## **KHNP Response to Request for Additional Information No. 2-7371**

TR section 4.2 describes four (4) cases of tests carried out to verify the performance of the VAPER SIT with test conditions summarized in Tables 4.2-1 through 4.2.5.

Figure RAI-10 A schematic diagram of the SIT-FD

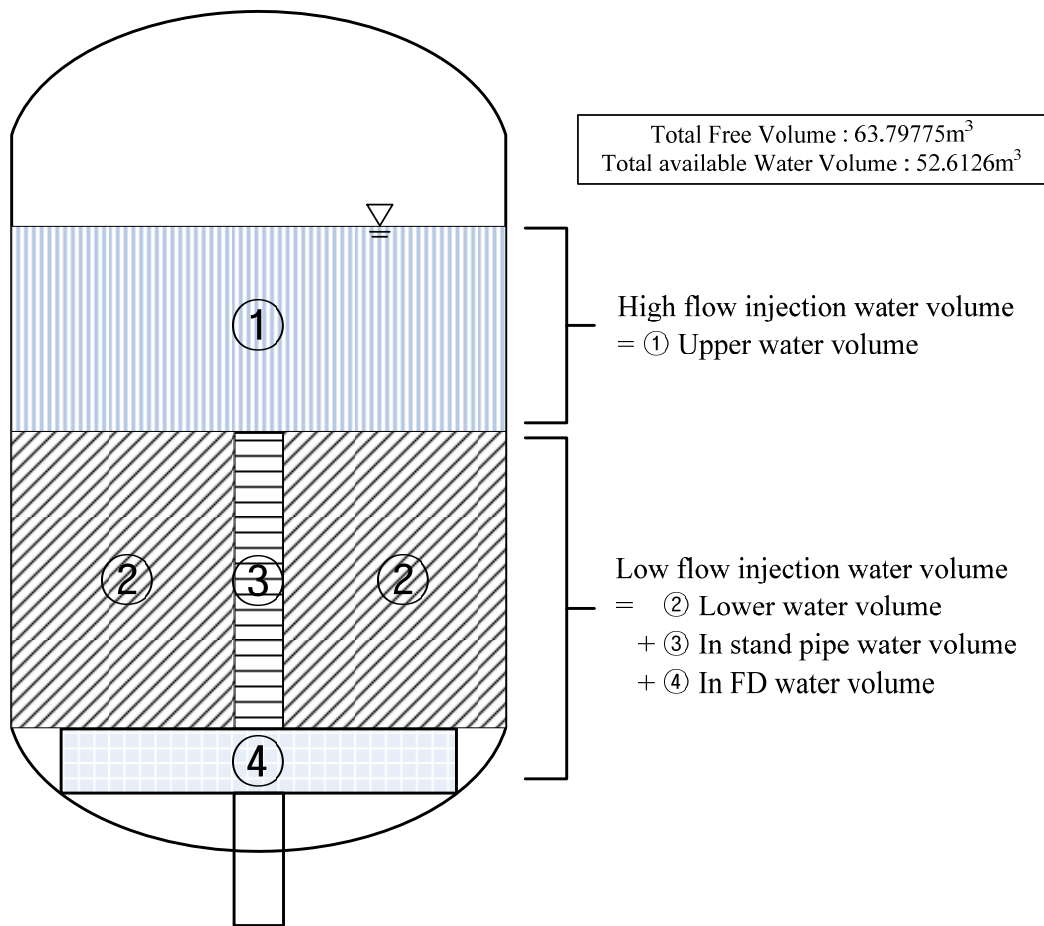
- In all tests do the flow rate turning points (switching from large to small flow rate) occur when the SIT water level decreases to the stand pipe elevation?
- What are the variations of the SIT water level from the stand pipe elevation observed in these test?
- In the LOCA safety analyses, what is the criterion used to determine the flow rate turning or switchover from the large-flow injection phase to the small-flow injection phases so that the corresponding K-factors can be used?
- How is the variation or uncertainty of the SIT water level for flow rate switching accounted for in the safety analyses?

*a&b) Table RAI-10 shows the Flow Rate Turning Time (Column [A]) and the difference between SIT water level and top elevation of stand pipe height at the flow rate turning time (Column [E]). The flow rate turning time corresponds to the time when the stand pipe water level starts to decrease abruptly.*

*Column [B] is the SIT water level at the flow rate turning time. Column [C] is the length (or height) of stand pipe.  $\Delta H$  in Column [D] is the elevation difference from the reference elevation of SIT water level (SIT bottom) to the elevation at the bottom of the stand pipe.  $\Delta H$  is*

*[ ]<sup>TS</sup>. The SIT water level at the flow rate turning time is, on average, [ ]<sup>TS</sup> higher than the top of the stand pipe. The standard deviation for the difference (Column [E]) is [ ]<sup>TS</sup>.*
